The Reid Supply Company

Mr. John Goetz, Chief
Hazardous Waste Section
Bureau of Waste Management
Forbes Field
Topeka, Ks. 66620

July 9, 1984

Below is Reid Supply Company's response to the KDHE-EPA Notice of Deficiency/Letter of Warning of June 15, 1984. The comments and concerns are addressed as they appear in the letter.

LOCATION OF EMERGENCY EQUIPMENT (Part 1)

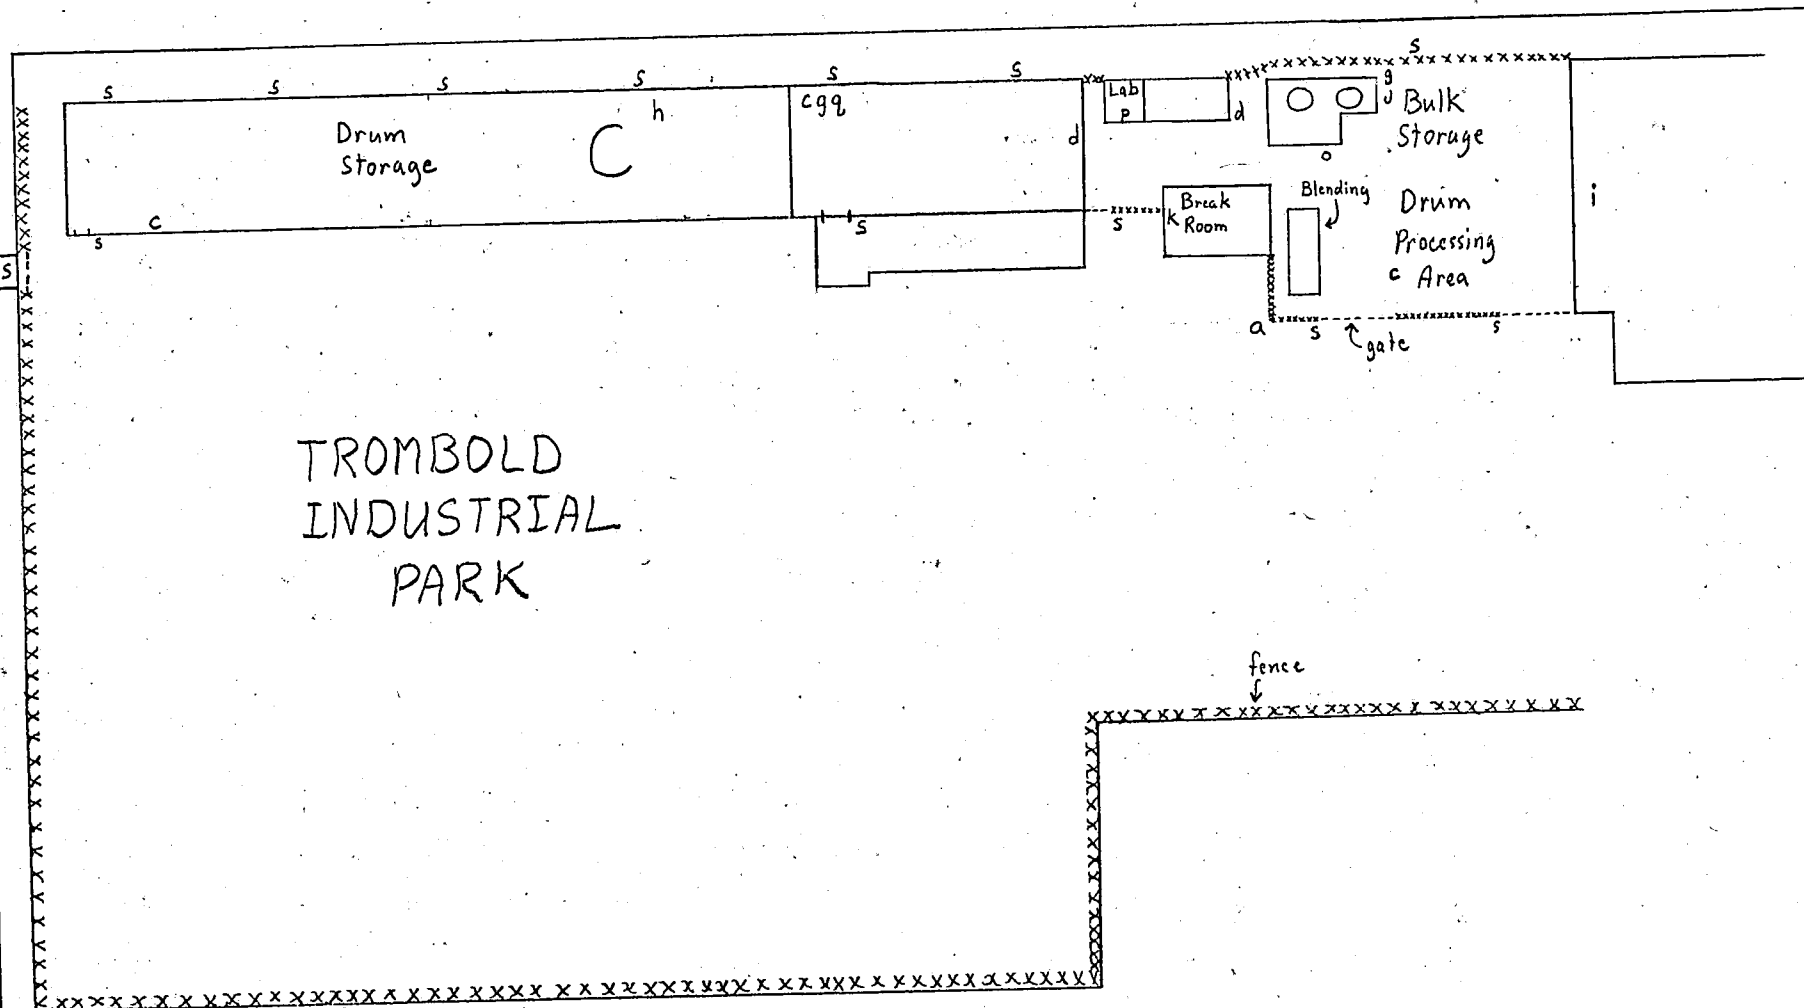
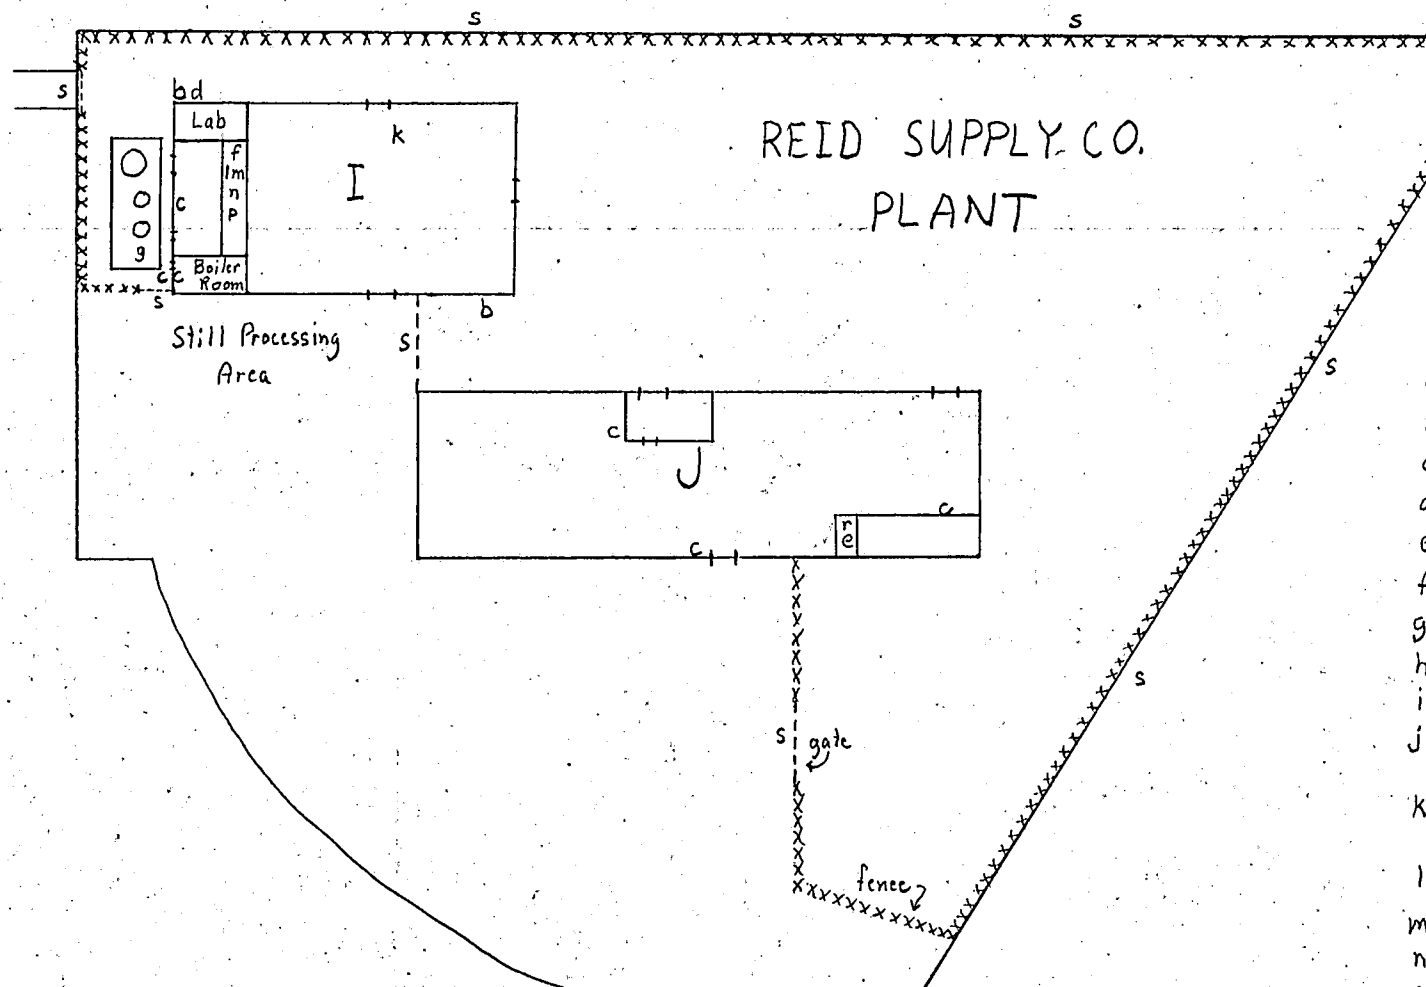
5. A. The alarm has been installed since May 1984. The alarm will be used for spills as well as fires. The same signal will be used for both and evacuations will be initiated by the alarm.
- B. The two process technicians will be the only regular employees working in the drum storage and tank storage areas except for a part time lab technician working in the lab at the end of C Building. In case of a fire or spill this employee would easily hear the alarm located 20 feet from the lab.
- C. Please note the telephones shown in the map of Location of Emergency Equipment.

8. No smoking signs have been placed inside the drum storage area in order to be fully visible from every position in the area. See Location of Emergency Equipment Map.
9. The Fire Department is in the process of finalizing their decision concerning the buffer zone waiver. Our insurance company, Aetna Life and Casualty, would not allow comment in favor of the waiver by order of the head office of the company even if our agent originally had no problem with the waiver. It appears that some people perceive that verbal commitments are easier to make than written ones. Word from the Fire Department should be coming the next two weeks.
